AENC-NG-CNS-REP-0292

Norwich to Tilbury

Document: 8.9.1 Applicant's Responses to First Written Questions

Planning Inspectorate Reference: EN020027

Title:
GEN1.15 - Norwich Main and Bramford substations and Tilbury North site Norwich Main

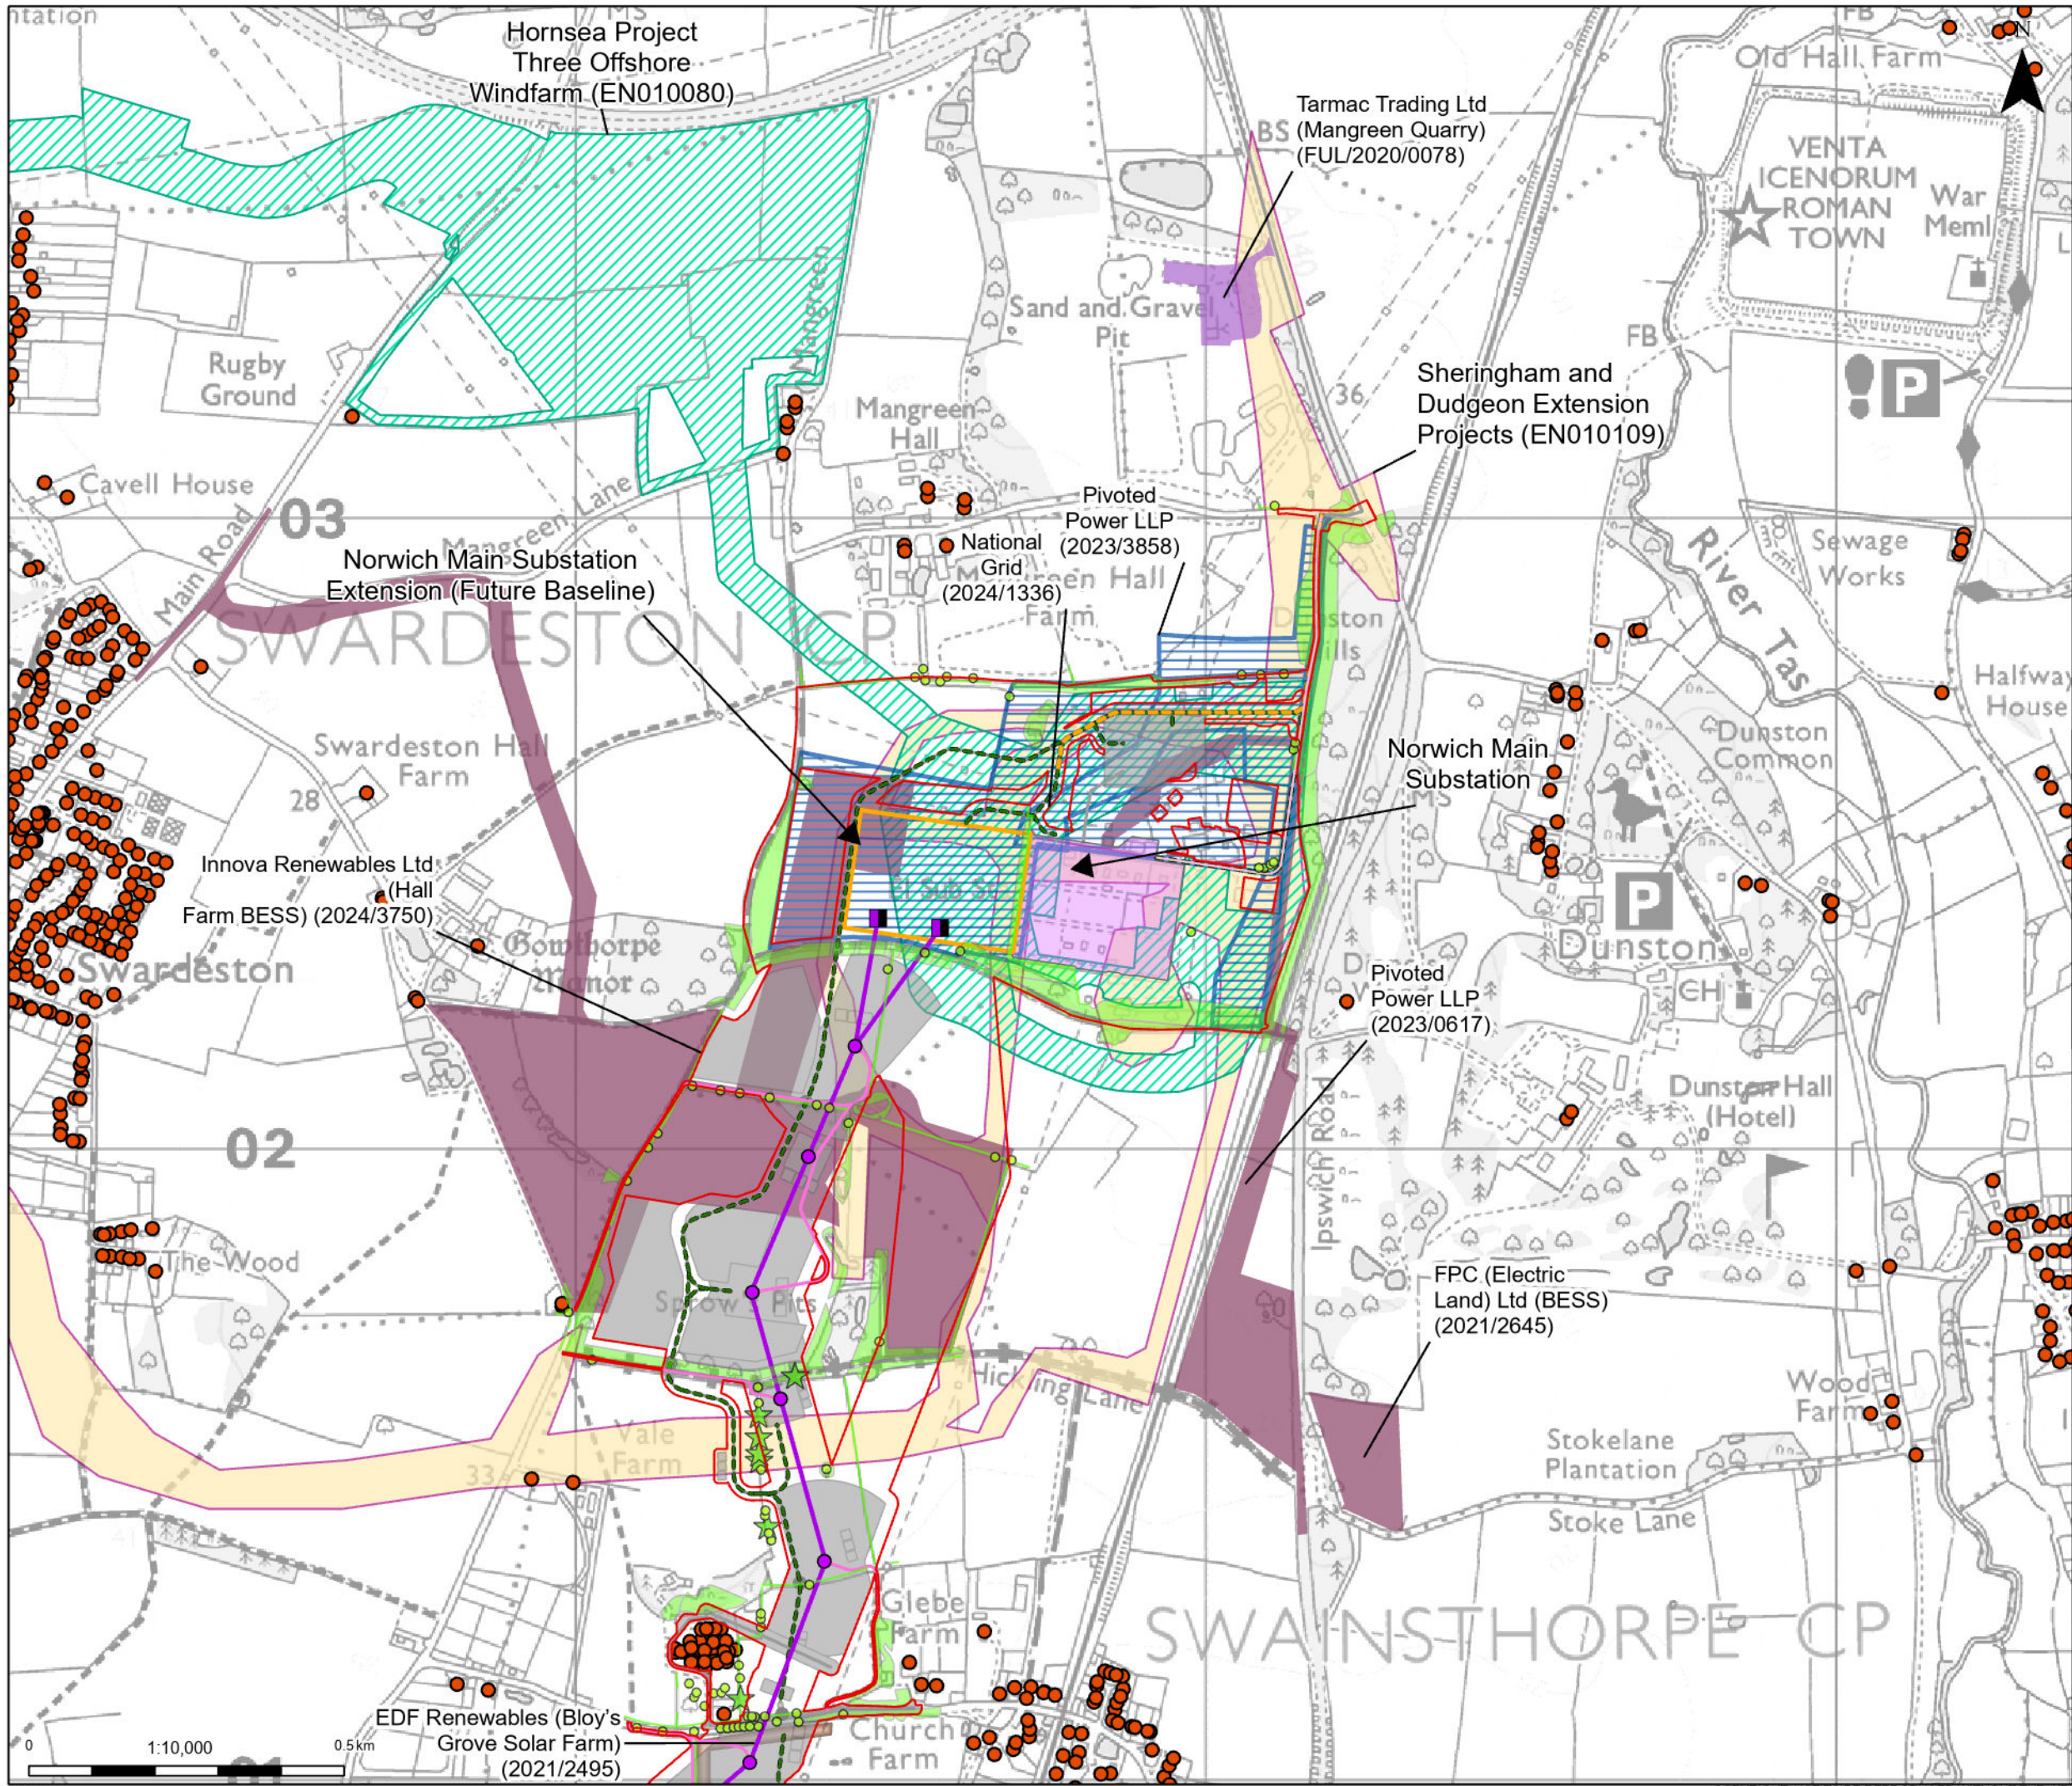
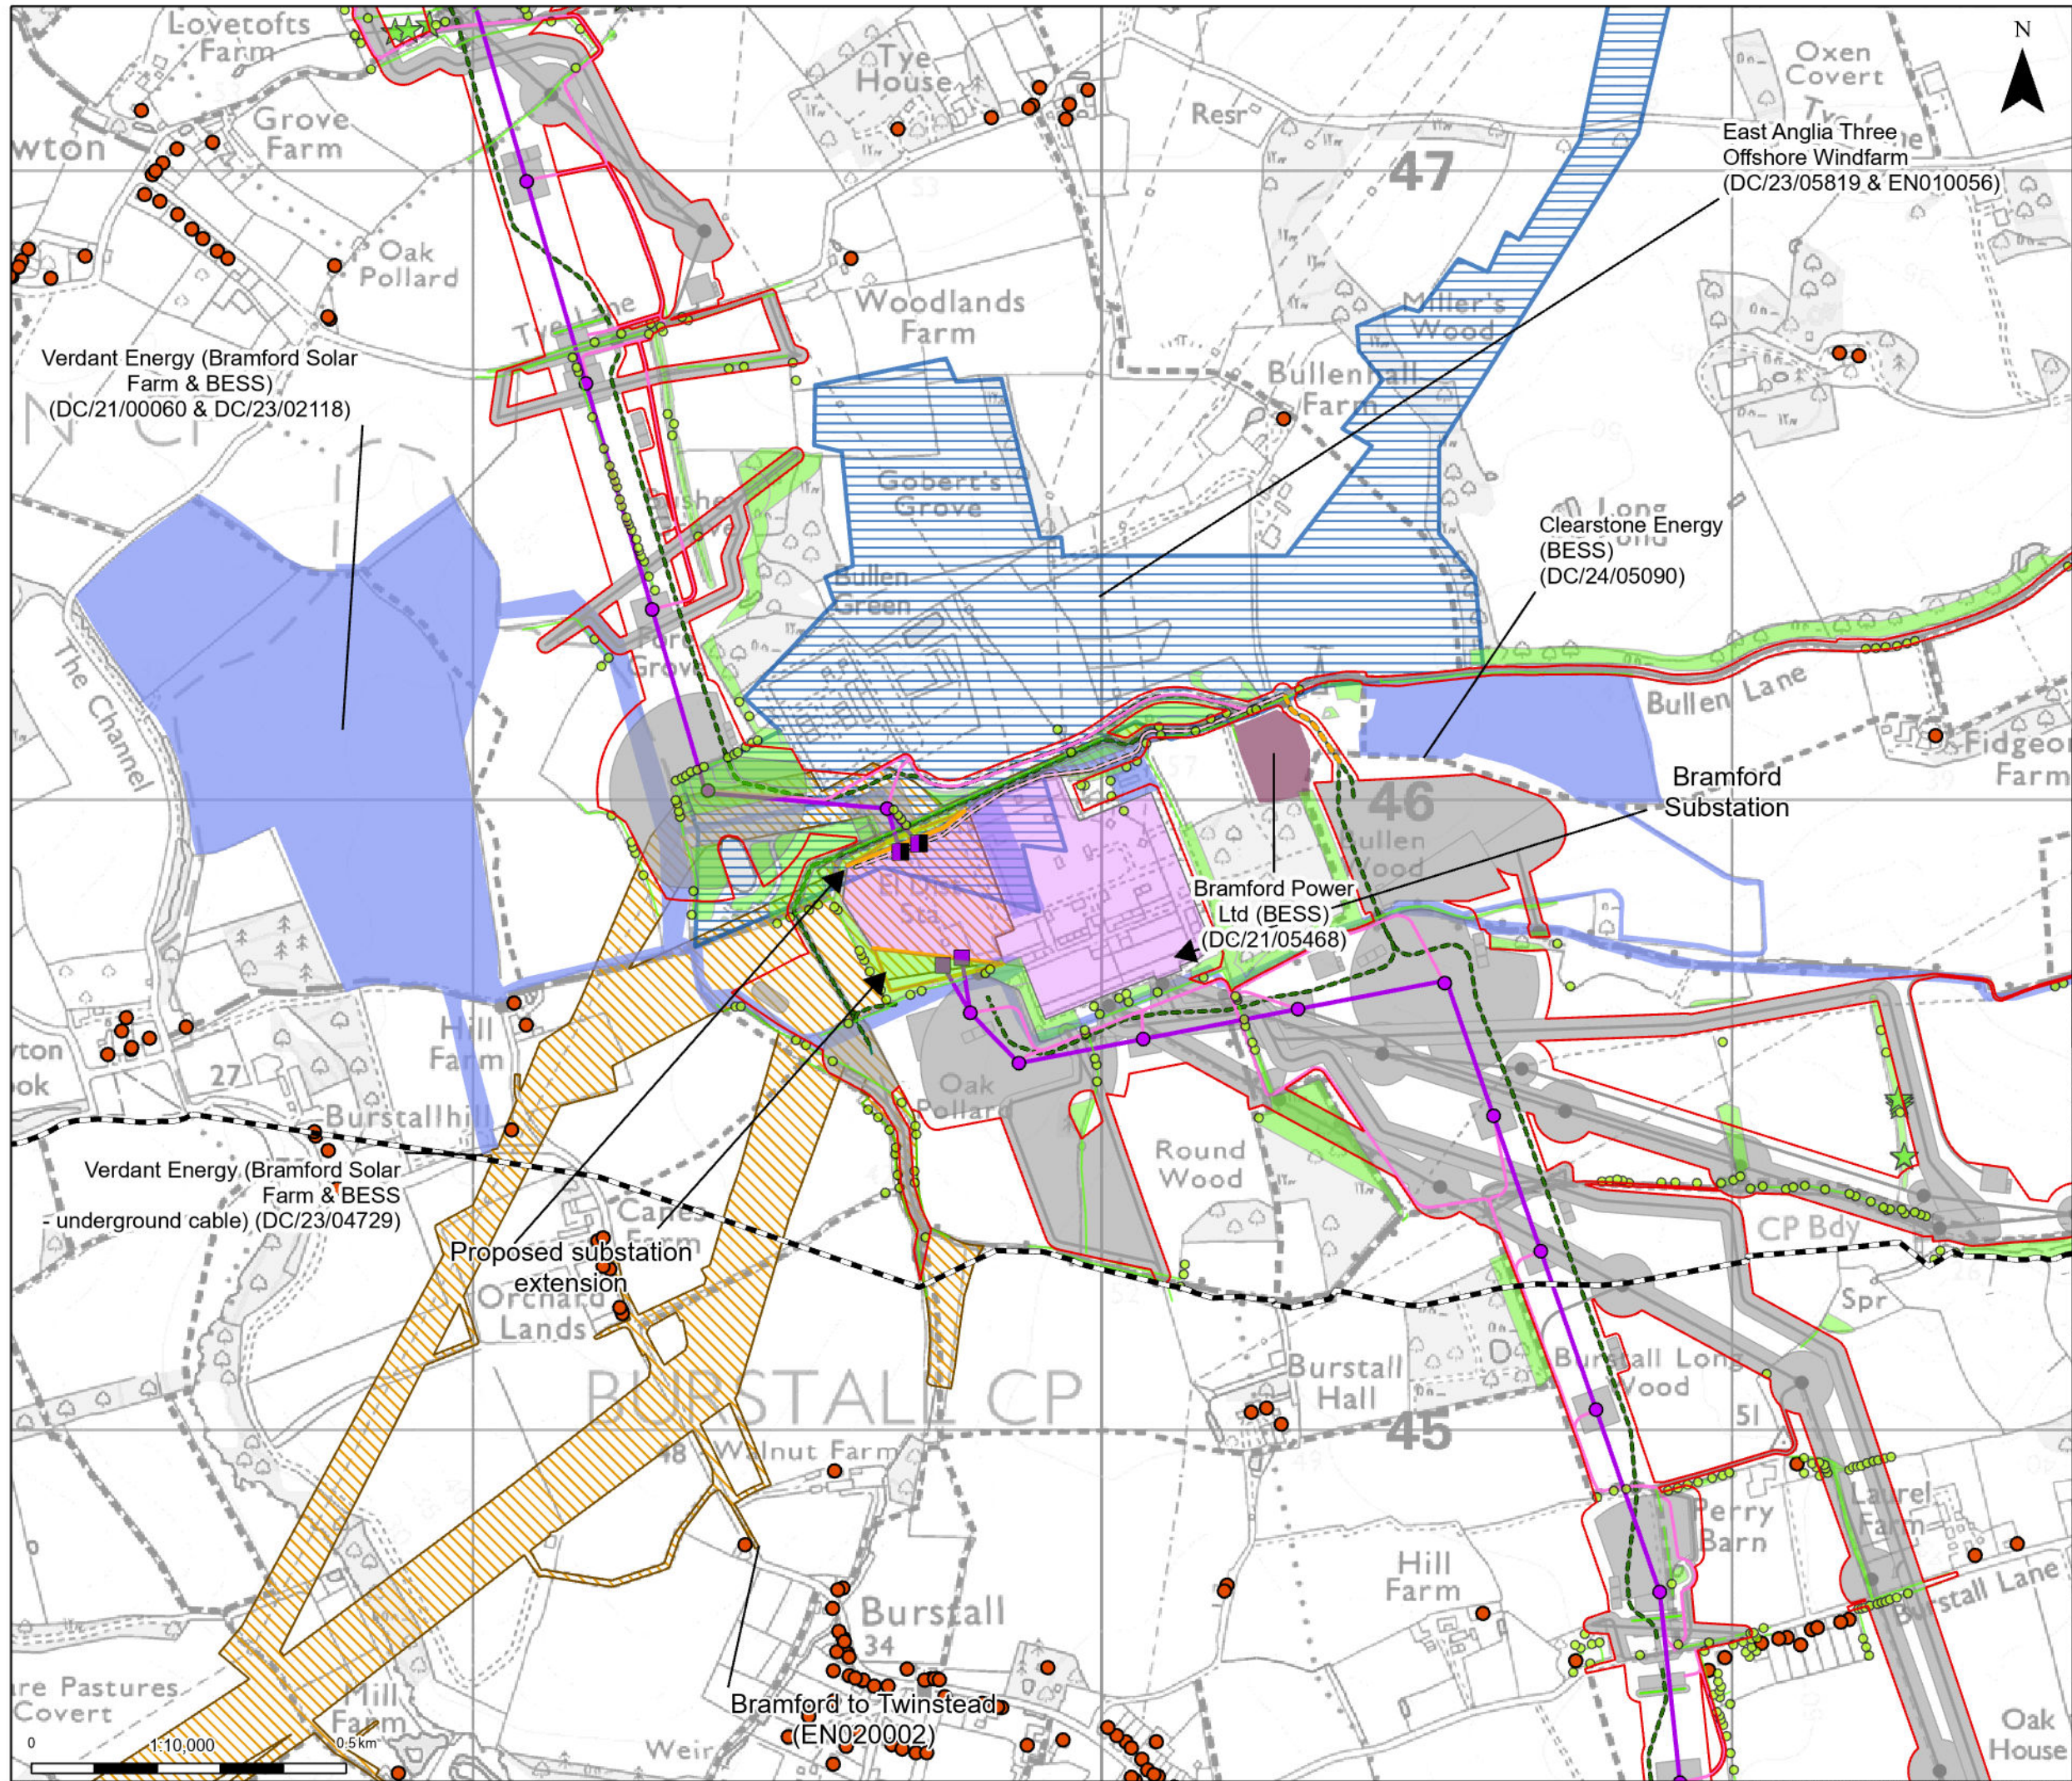
GEN 1.15	Norwich Main and Bramford substations and Tilbury North site – other developments Similar to the previous question, the ExA seeks separate labelled plans to an appropriate scale for the areas around the existing Norwich Main and Bramford substations and the proposed Tilbury North site which detail the surrounding existing and proposed developments, existing and proposed landscape features and access roads. Standalone plans should be provided at deadline 3 and incorporated in the	The Applicant has provided the requested plans in Appendix B to this document. The plans produced in response to this question have been labelled '<i>GEN 1.15 - Norwich Main and Bramford substations and Tilbury North site</i>', with separate sheets for each of the three locations. In addition, a separate plan has been provided for the area around the Norwich Main Substation that shows landscaping detail – please also see further explanation below. These plans will be incorporated into the next version of 8.4.3 Report on Interrelationship with Other Infrastructure Projects [REP1-134], due to be submitted at Deadline 4 of the examination. In producing these plans, the Applicant has used the following approach: - Scale: each plan has been produced at 1:10,000 scale - Project: the Tilbury North plan references the Project design at application, so reflecting the design prior to the Applicant's decision to proceed with scenario B. As previously notified to the ExA, Project design information is being updated later in examination, as confirmed in Additional Submission - Letter to the Examining Authority dated 9 February 2026 [AS-084] and 8.6.1 Deadline 1 Cover Letter [REP1-141]

Reference	Question	Applicant's Response
	next version of the interrelationship report at deadline 4.	- Surrounding existing and proposed developments: developments included in 6.17.F2 Environmental Statement Figure 17.2 - Short List of 'Other Developments' Considered within the Cumulative Impacts Assessment [APP-286] have been included and labelled with a reference to the development / developer name (consistent with any name used in 8.4.3 Report on Interrelationship with Other Infrastructure Projects [REP1-134]) and the planning application / Nationally Significant Infrastructure Project reference - Existing and proposed landscape features: - Existing landscape features: existing trees and hedgerows have been included. These features along with the impact on them are detailed on 6.13.A6 Environmental Statement Appendix 13.6 - Arboricultural Impact Assessment (AIA) Figure A13.6.1 - Arboricultural Impact Assessment [REP1-065] at 1:2,500 scale. - Proposed landscape features: features proposed at Norwich Main substation have been included on the additional version of the plan for that location. Plans for Norwich Main with and without proposed landscaping have been included due to the amount of information shown on the plans, to assist the Examining Authority's identification of the landscaping aspects. No landscaping is proposed for Bramford Substation due to space constraints. Proposed landscaping relating to Tilbury North earlier shown on application documents including 7.4 Outline Landscape and Ecological Management Plan Appendix D - Outline Landscape Proposals [APP-325] has not been included on the plan for that location, as updated detail is due to be produced and provided to the examination subsequent to the Applicant's notification to proceed with scenario B - Access roads: Project permanent and temporary access roads have been differentiated from other Project design data and labelled - Existing farmsteads and dwellings which bound the sites: The plans identify locations of these buildings rather than extents of entire landholdings, which may also include land
